UNITED STATES OF AMERICA  
NUCLEAR REGULATORY COMMISSION

_____	
In the Matter of	)
	)
PACIFIC GAS AND ELECTRIC COMPANY	)
	)
Diablo Canyon Power Plant	)
Units 1 and 2	)
_____

License Amendment Request  
No. 89-07

### TECHNICAL SPECIFICATIONS FIGURES 3.4-2 AND 3.4-3 AND ASSOCIATED BASES AND DELETION OF TS 4.4.9.1.2 AND SURVEILLANCE CAPSULE WITHDRAWAL SCHEDULE

FIGURE B 3/4.4-1

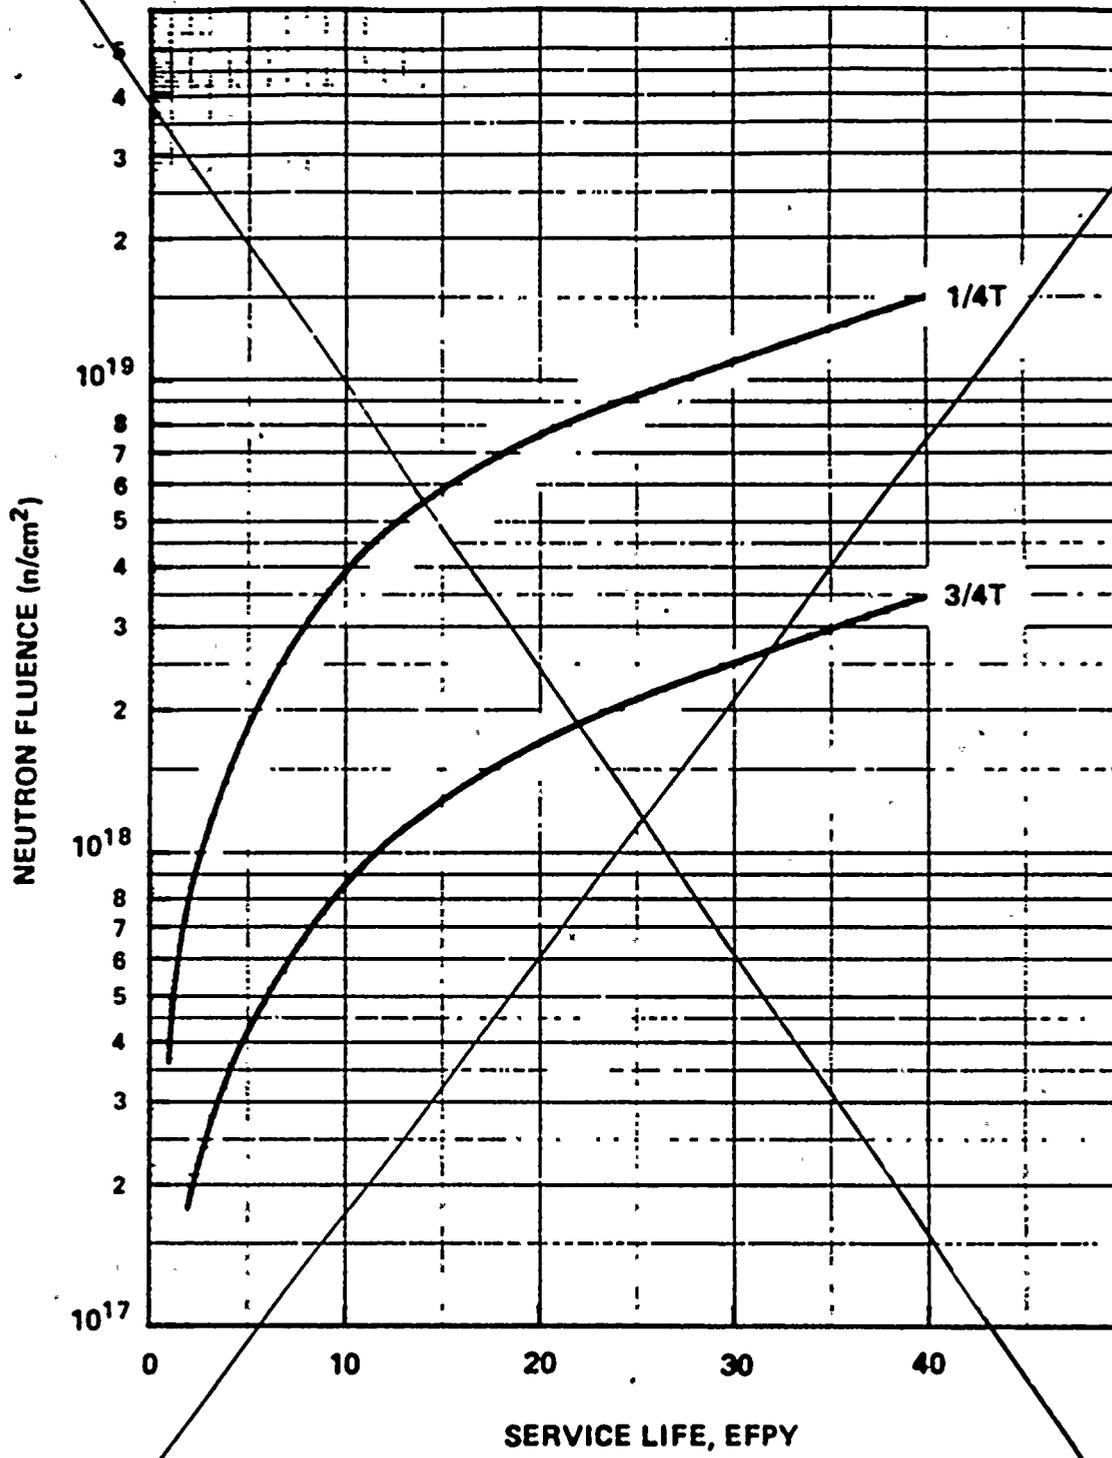
The proposed removal of TS Tables B 3/4.4-1a and B 3/4 4-1b, and TS Figures B 3/4.4-1 and B 3/4.4-2 and relocation to the FSAR Update will simplify future TS revisions. The information being removed from the TS is in the current DCCP FSAR Update. This data is not needed for reference by the Operations staff and will be accessible in the FSAR Update for engineering personnel.

DELETED

FIGURE B 3/4.4-2

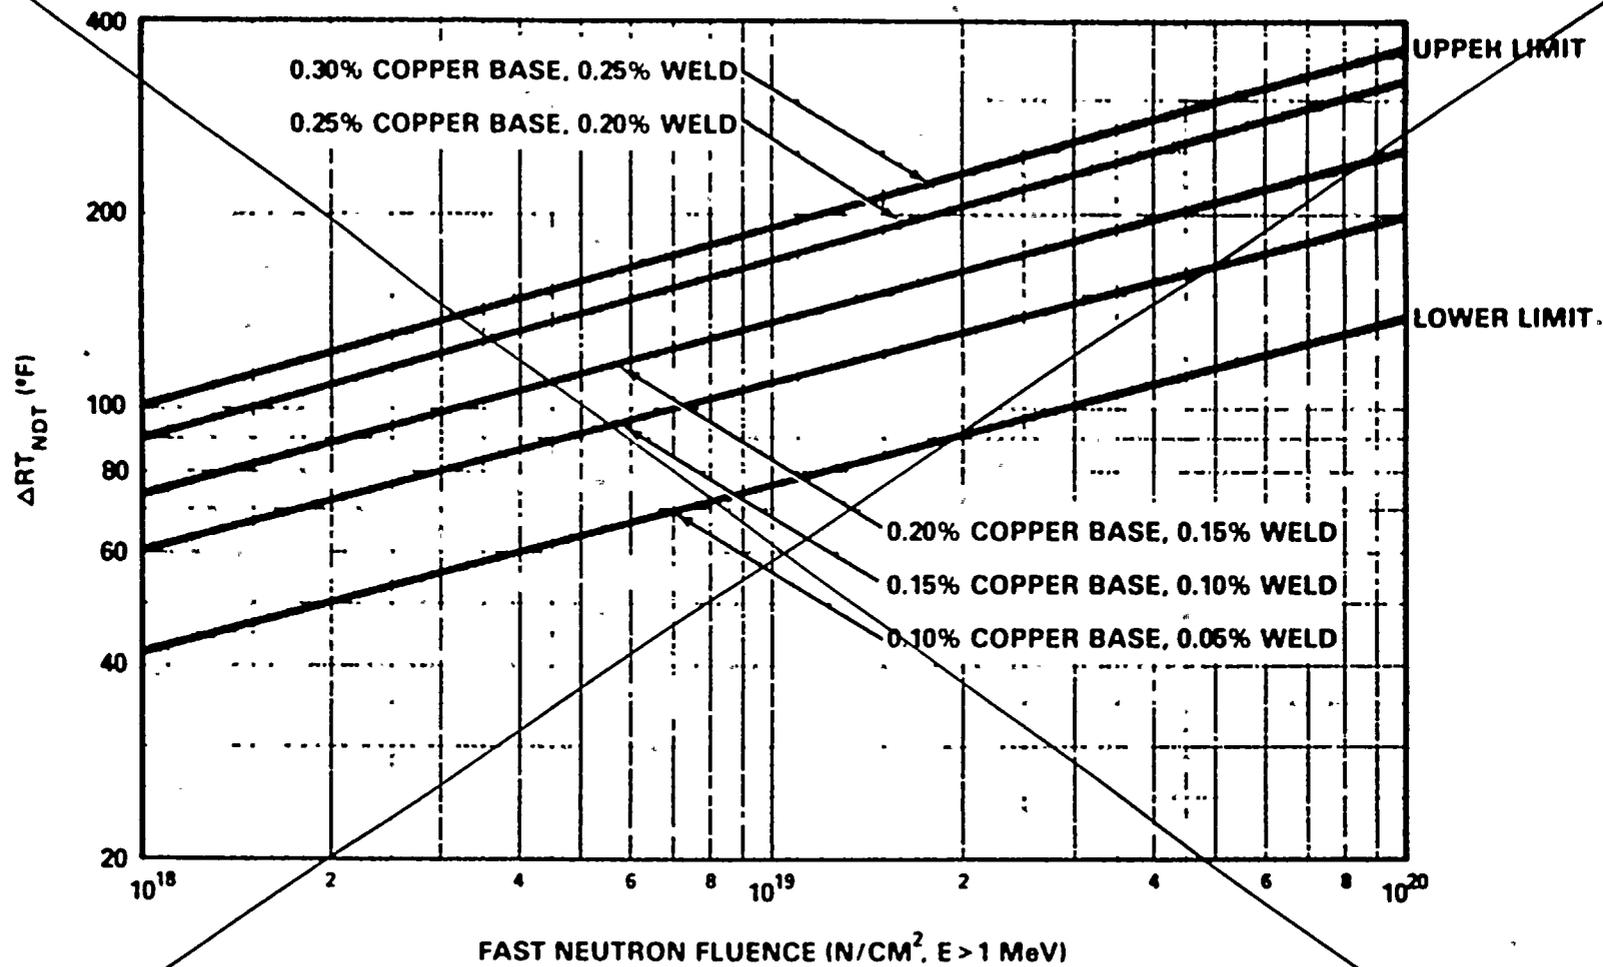
DELETE
